Memorandum

Subject: Horseshoe Ridge Block 1 Lot 1 – Learning Experience Site Plan – Engineering 1st Review

Drainage Report

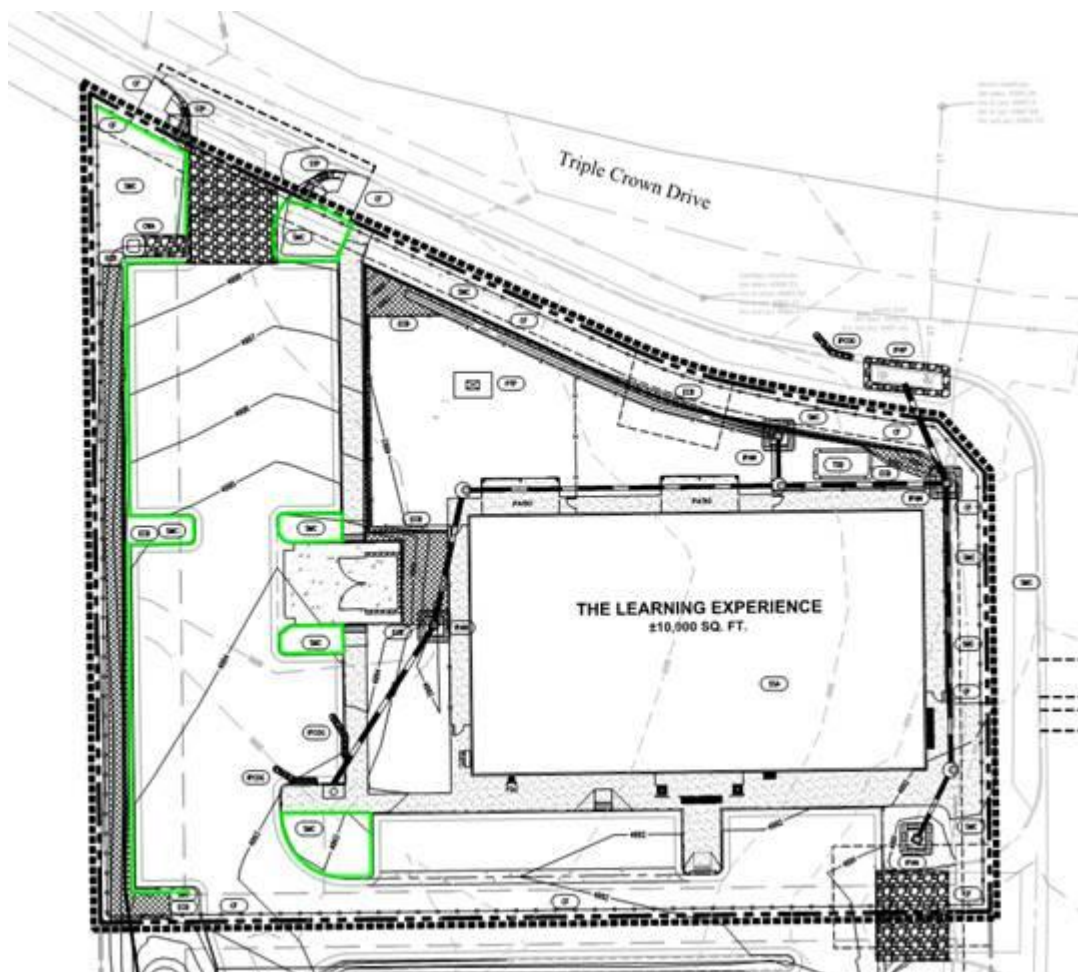
17. The length used in the Travel Time calculations for sub-basin 2.0 appears incorrect. Please revise as necessary.
18. The proposed analysis of the existing Pond III is insufficient. Please revise the UDFCD detention spreadsheet to include all contributing basins to Pond III (pull basin characteristics from Appendix D of the original drainage report). Complete the routing portion of the spreadsheet utilizing the existing outlet structure. Modifications to the outlet structure may be required to meet the current UDFCD release rates.
19. Provide a maintenance access road to the pond from the roadway stub of Tack Drive.
